**AMENDMENT 1**

TIBET ROAD  
(TRIBUTARY T TO E. 48TH AVE.)  
SITE PLAN FOR INFRASTRUCTURE  
TITLE: LANDSCAPE PLAN  
DATE: January 30, 2023

TIBET ROAD (TRIBUTARY T TO E. 48TH AVE.)  
SITE PLAN FOR INFRASTRUCTURE  
TITLE: LANDSCAPE DETAILS  
DATE: January 30, 2023

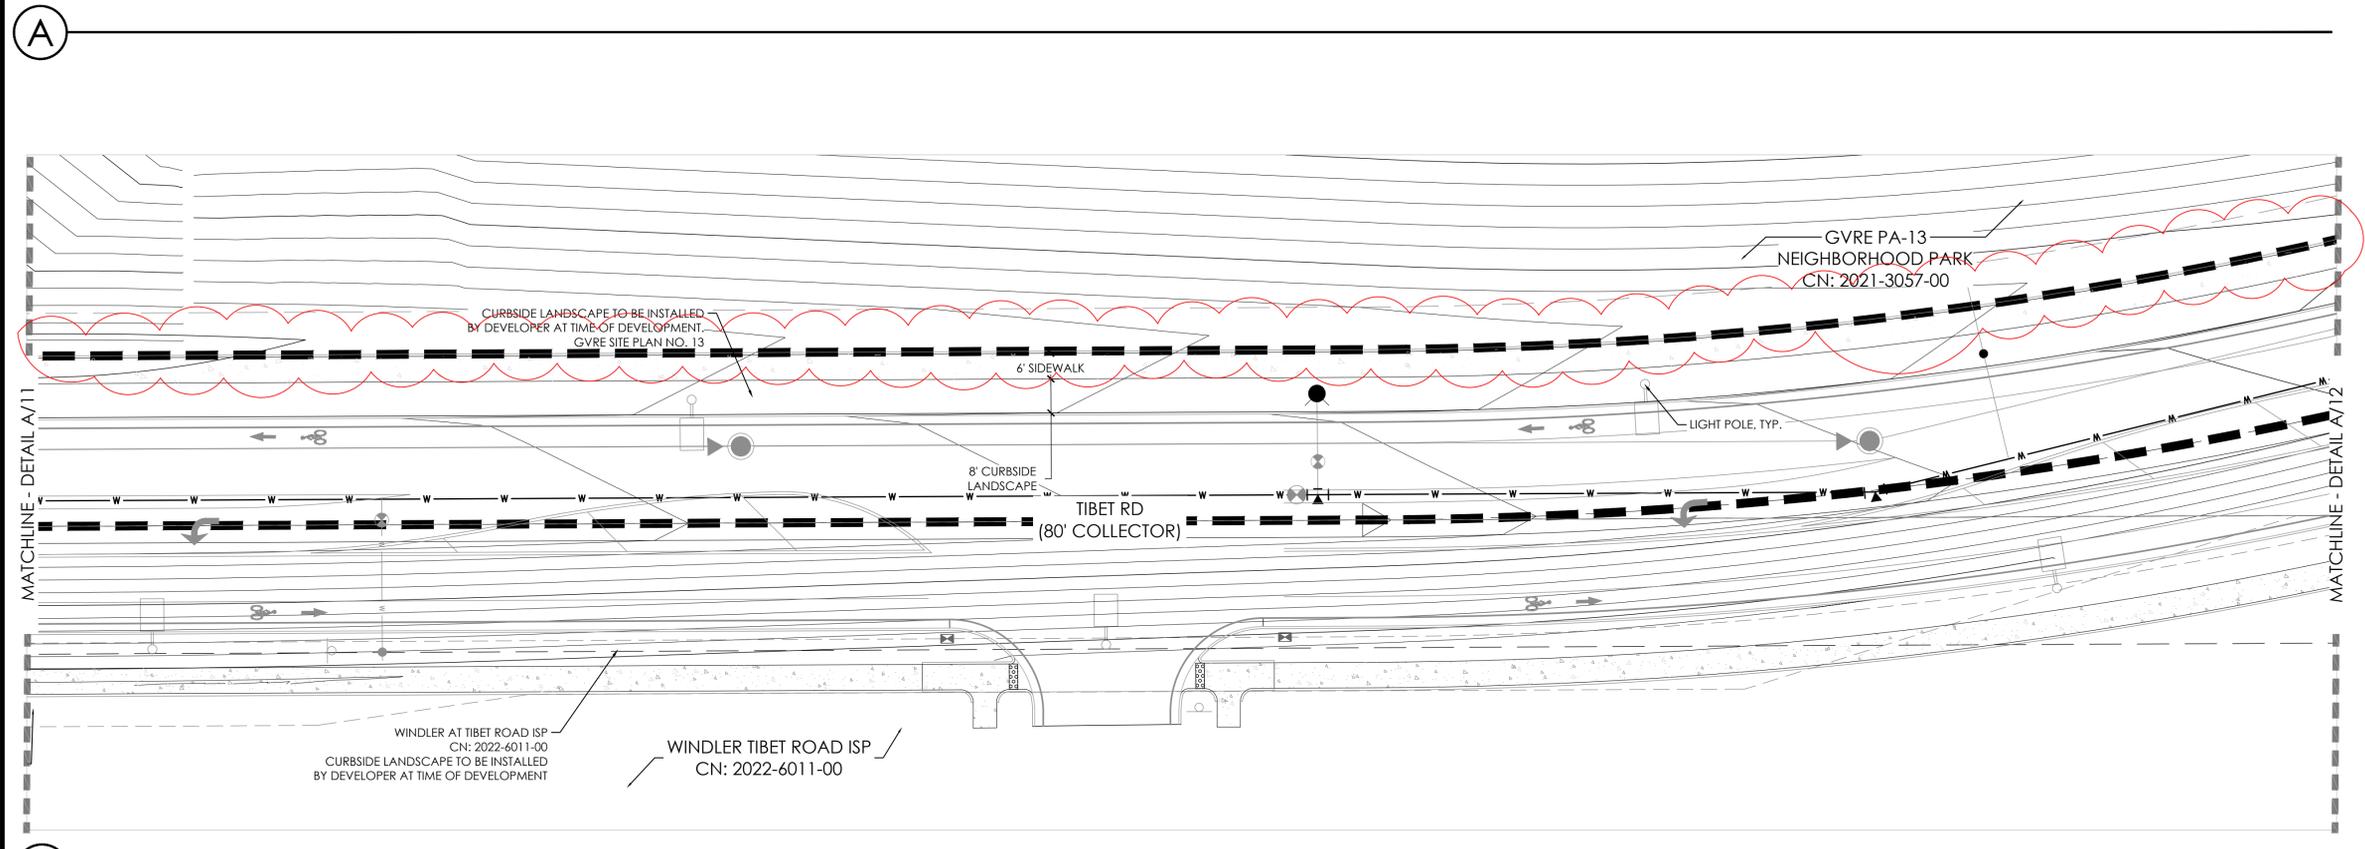
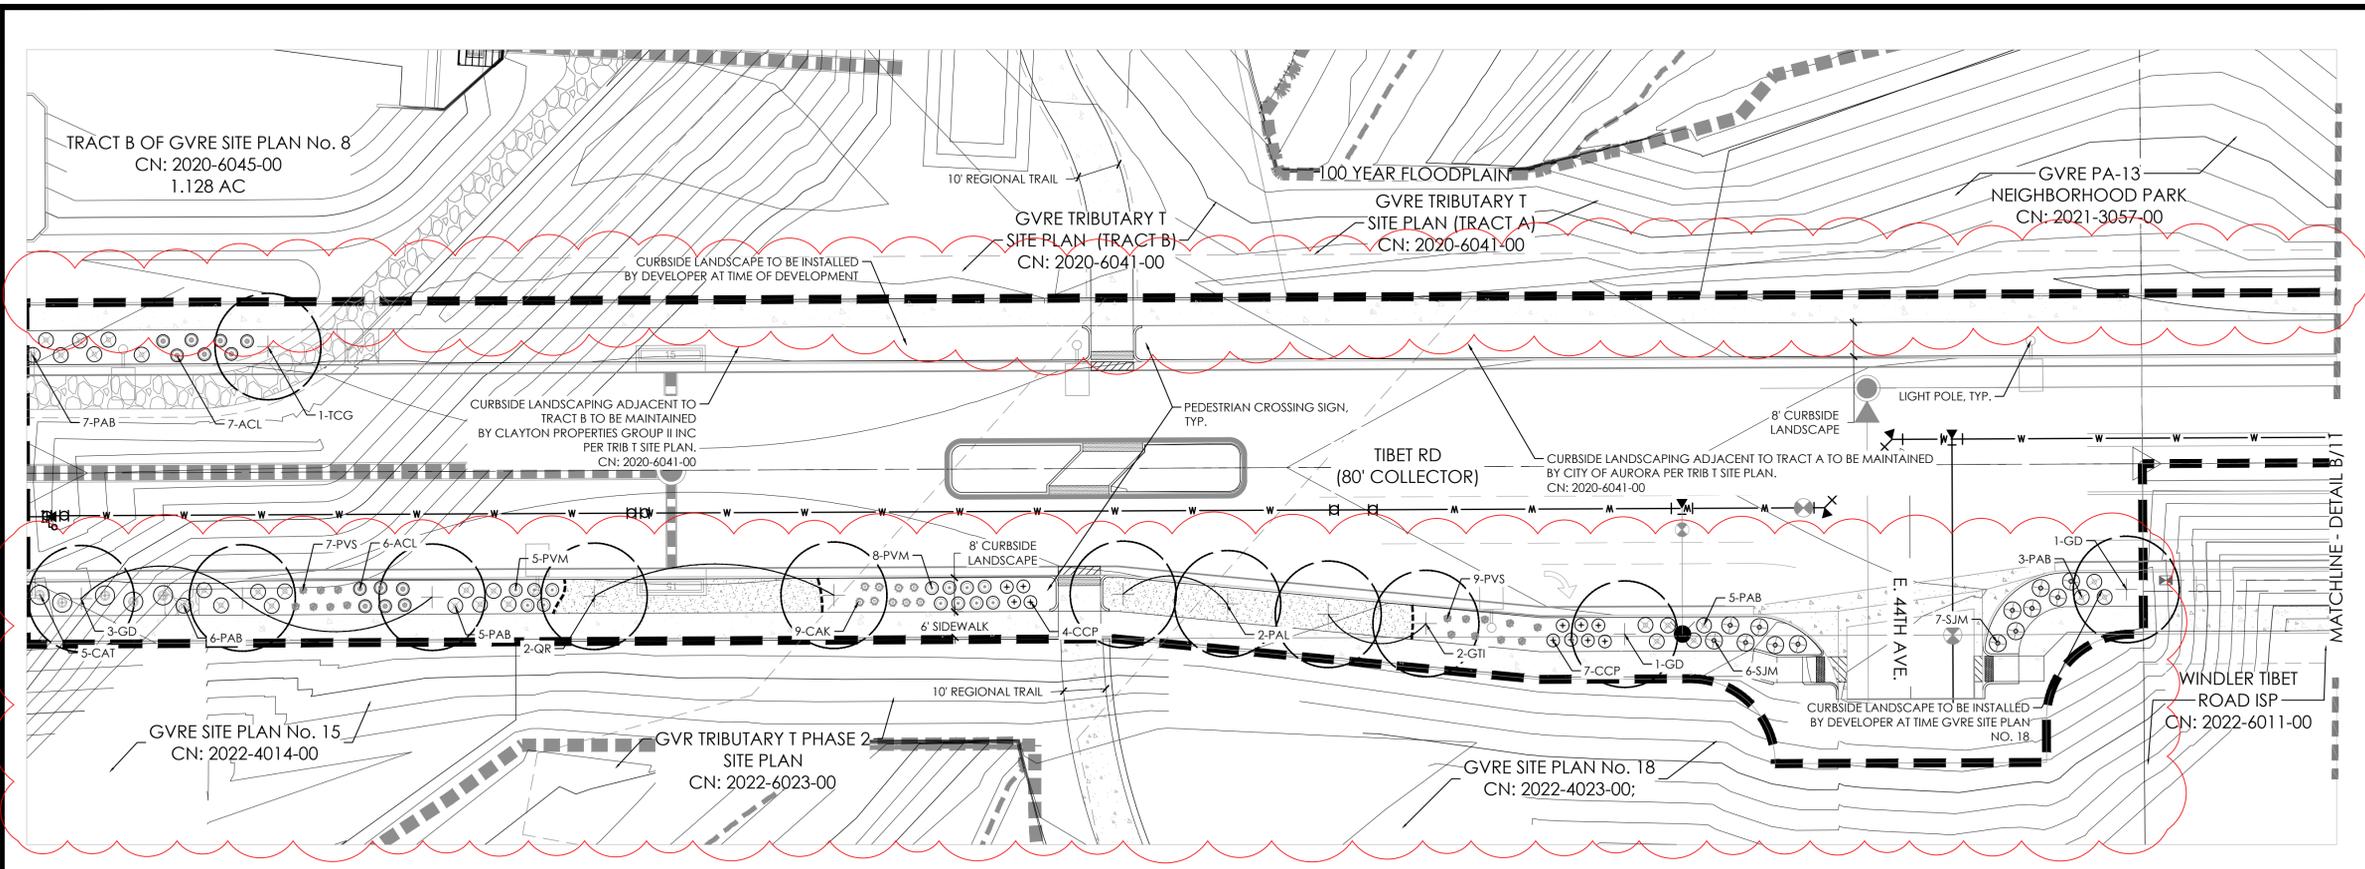
- REMOVE CRUSHER FINES BIKE PATH
- ADDED TURN LAND AND ROAD INTERSECTION INTO GVR FILING 18
- PLANTING ADDED TO CURBSIDE

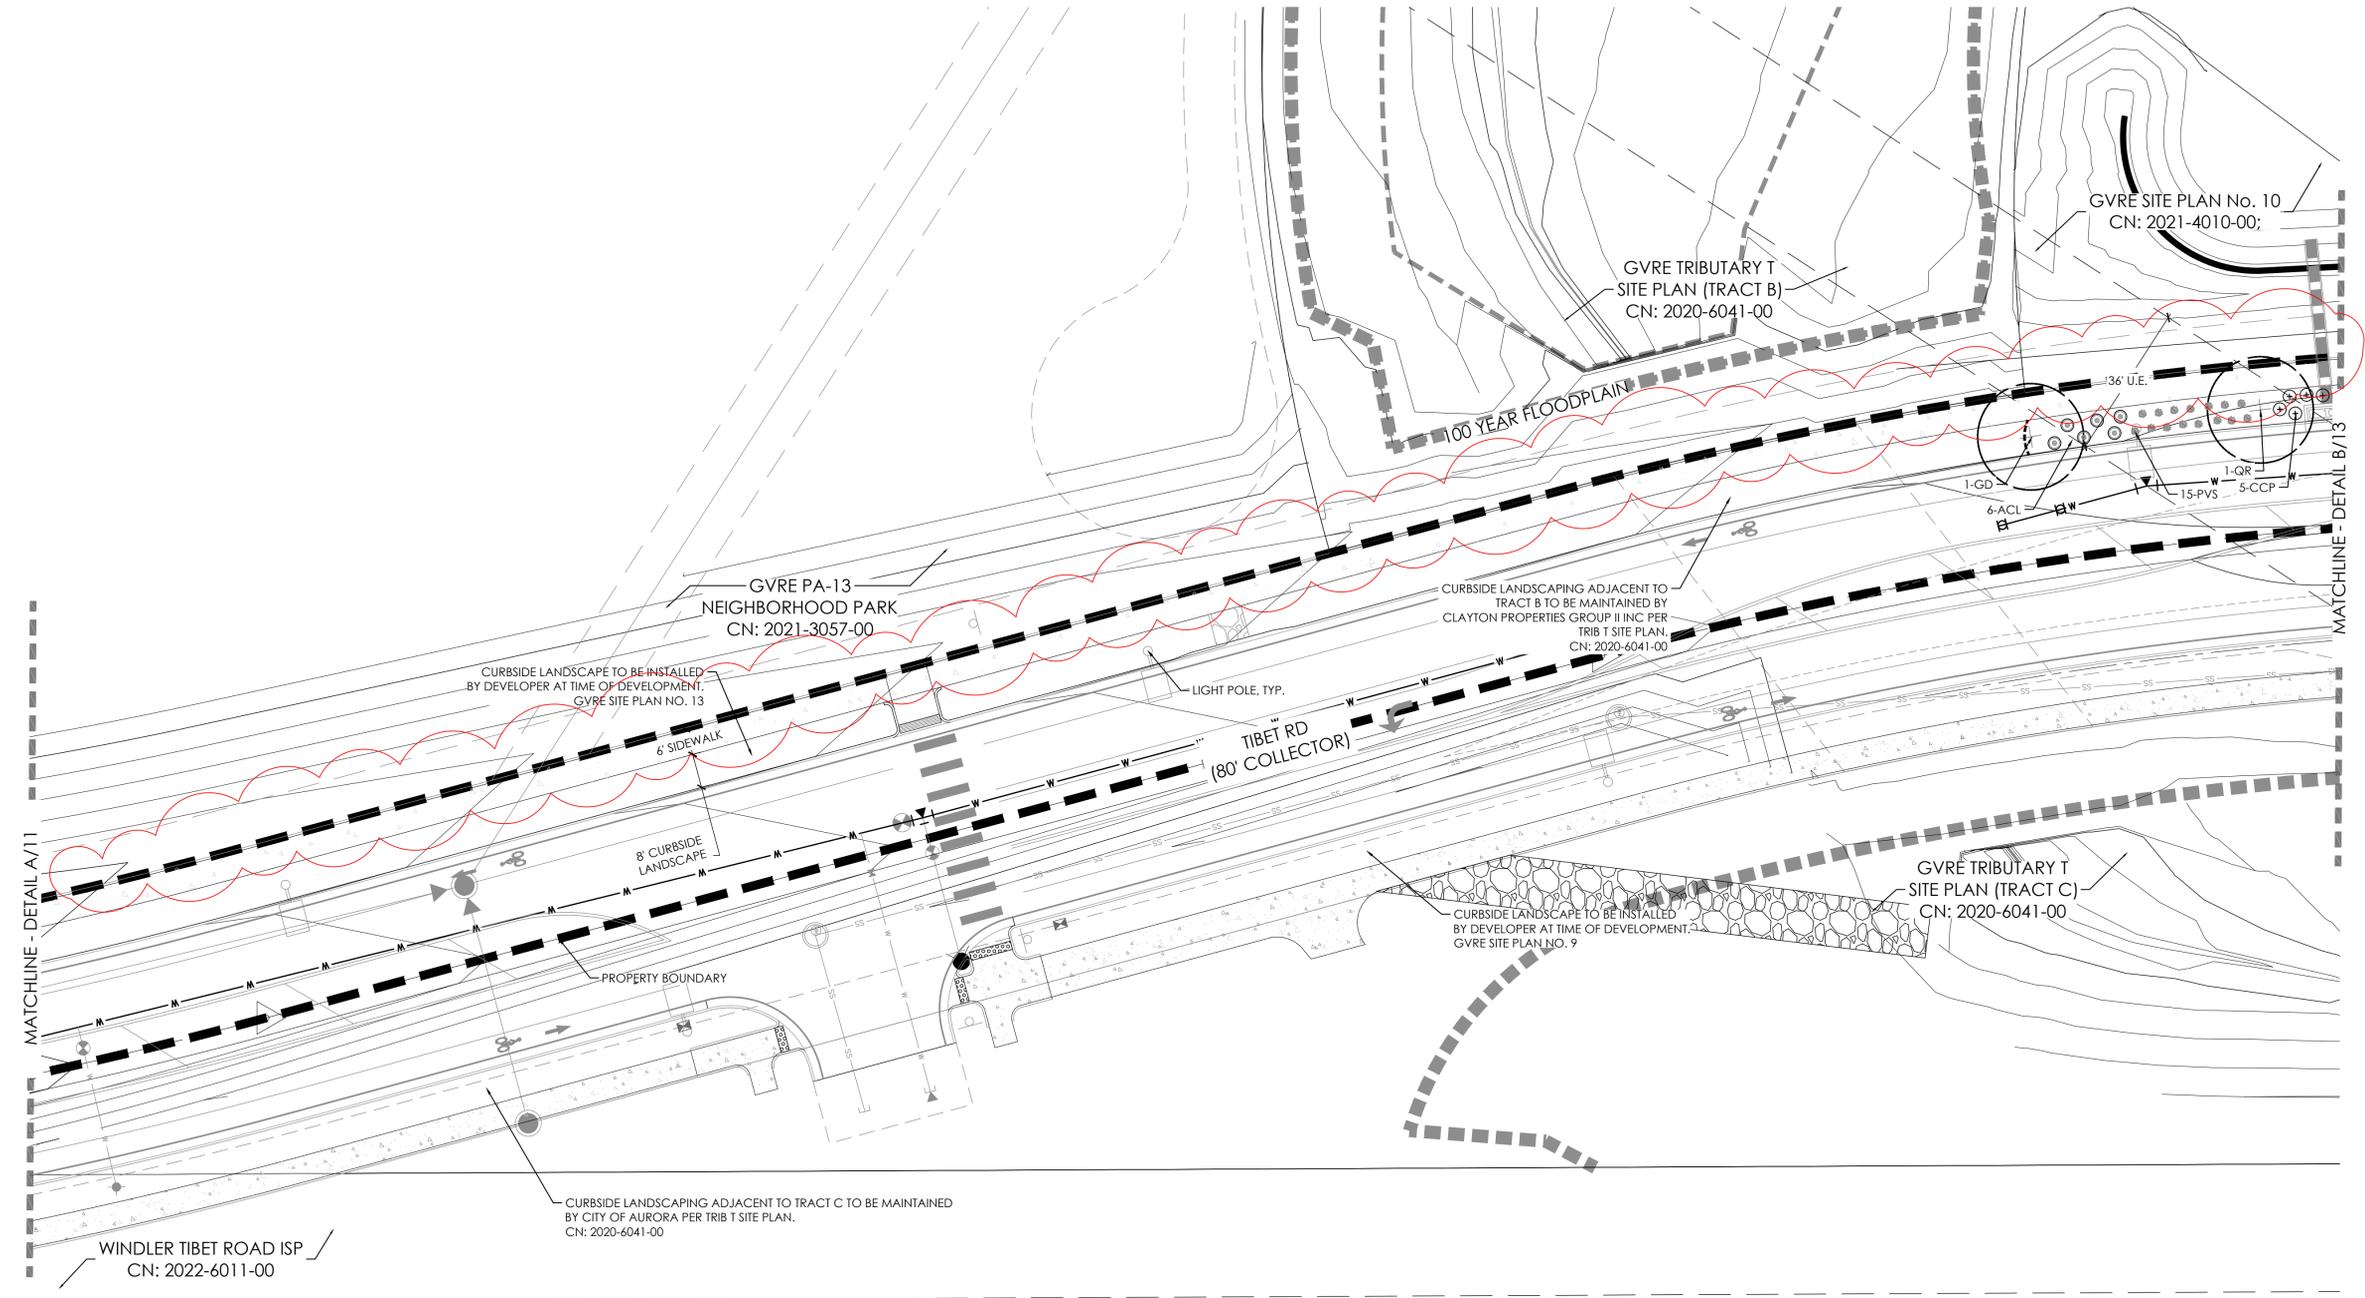
**AMENDMENT 1**  
- REMOVE CRUSHER FINES BIKE PATH

TIBET ROAD  
(TRIBUTARY T TO E. 48TH AVE.)  
SITE PLAN FOR INFRASTRUCTURE  
TITLE: LANDSCAPE PLAN  
DATE: January 30, 2023

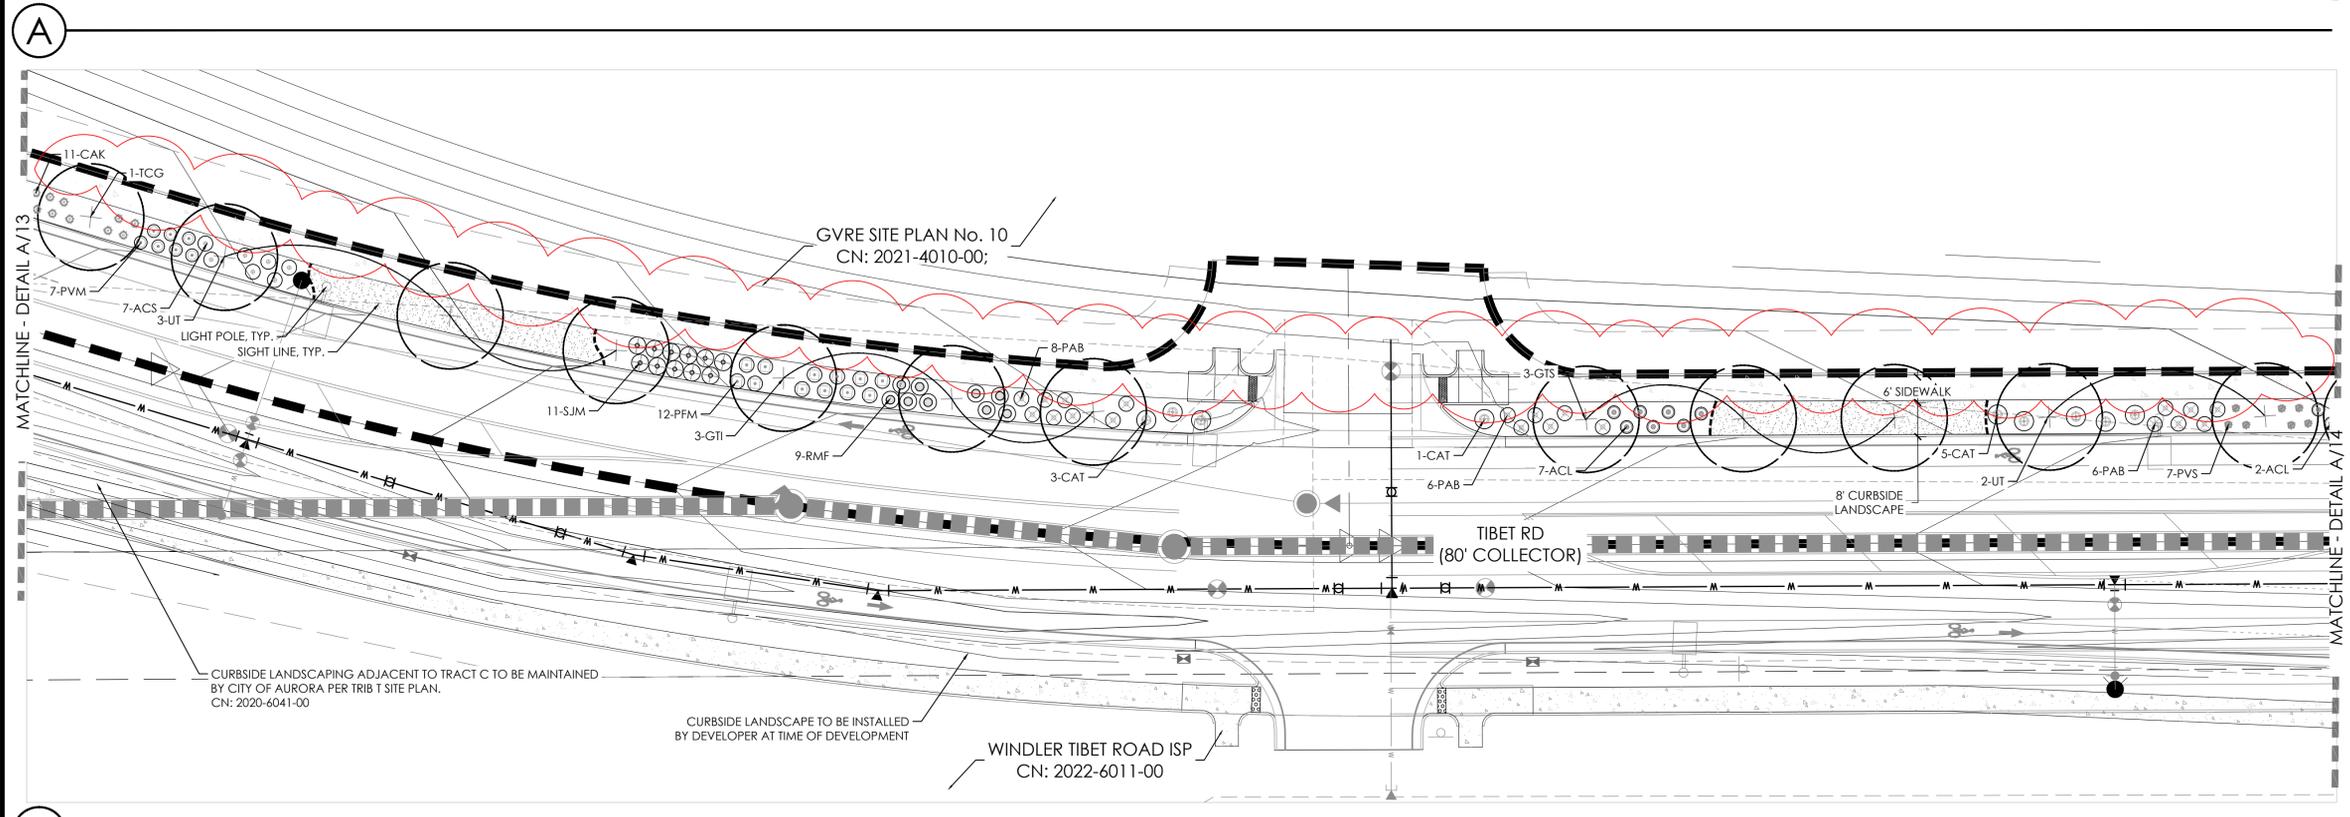
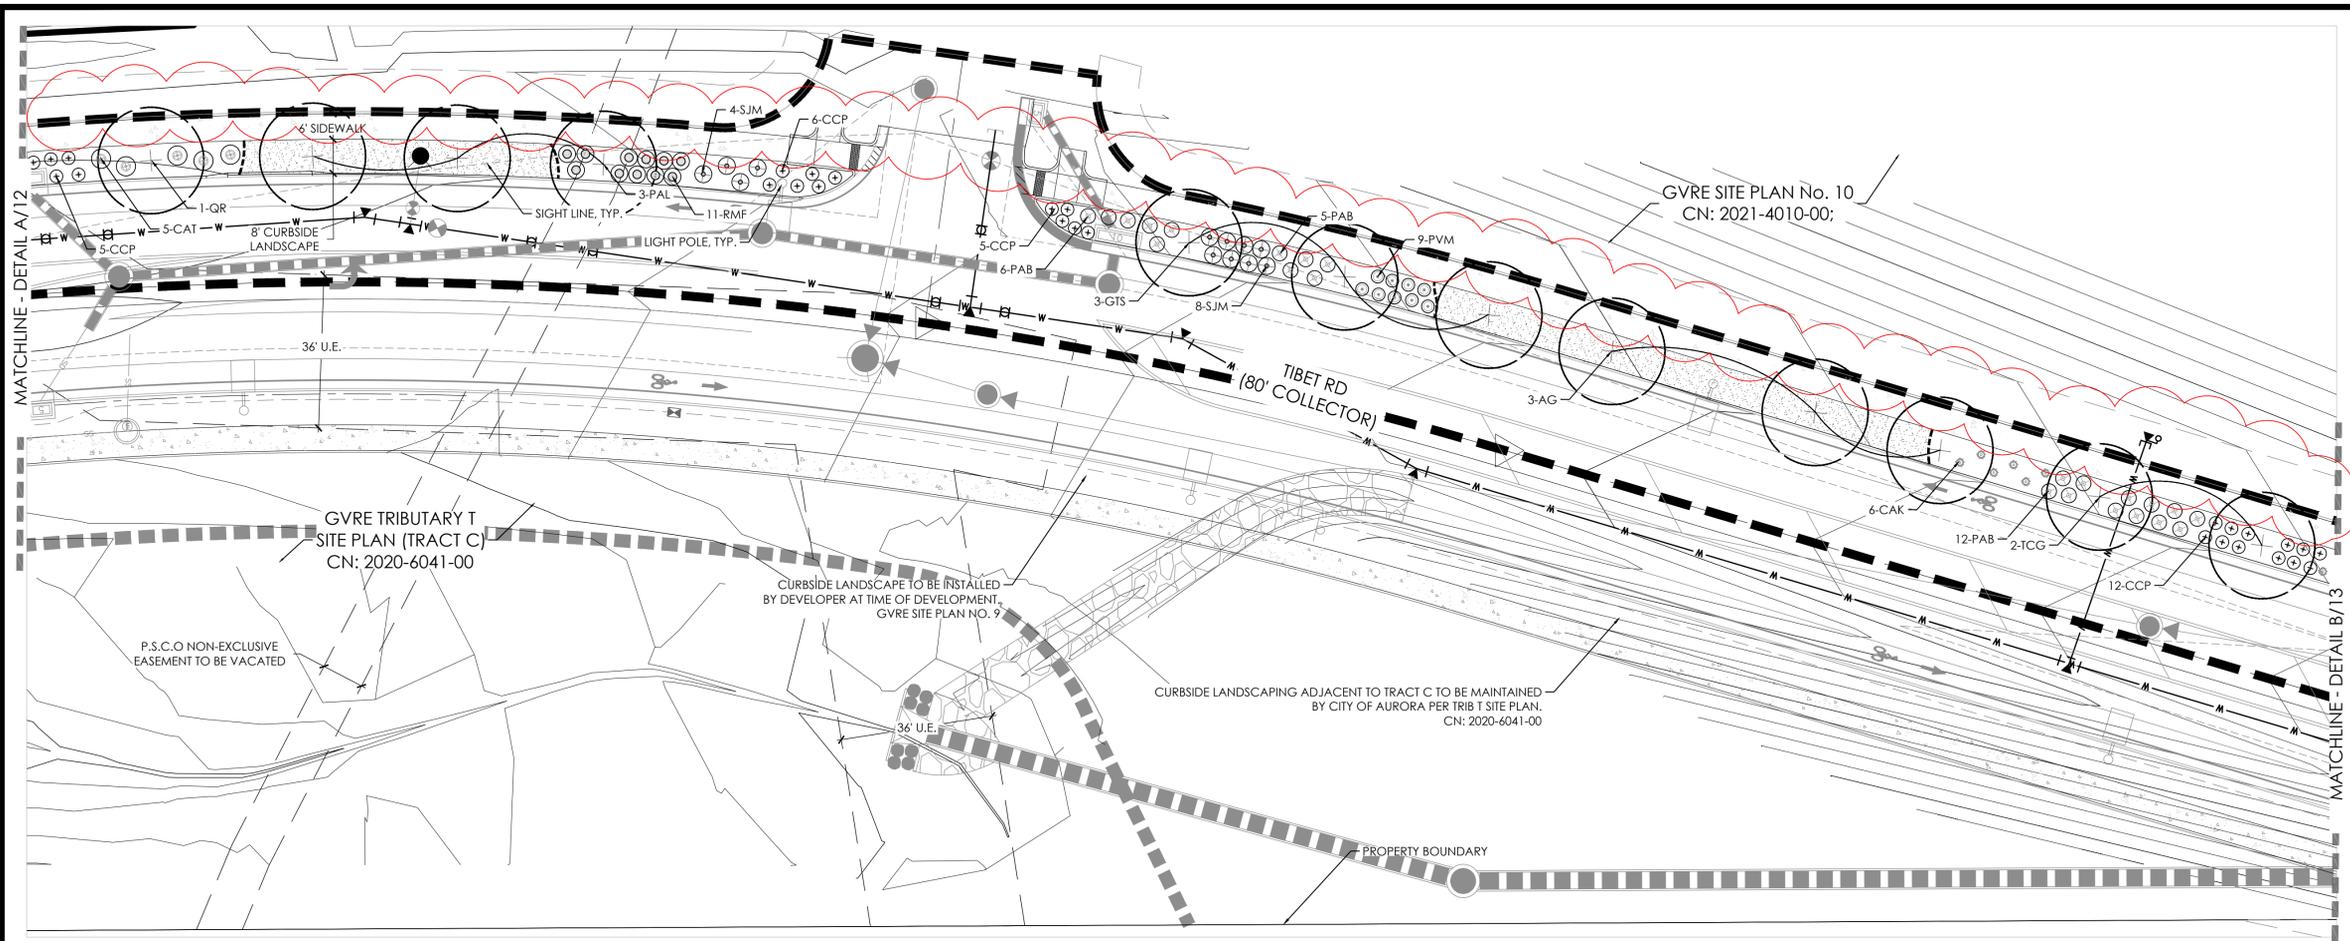
**AMENDMENT 1**  
- REMOVE CRUSHER FINES BIKE PATH
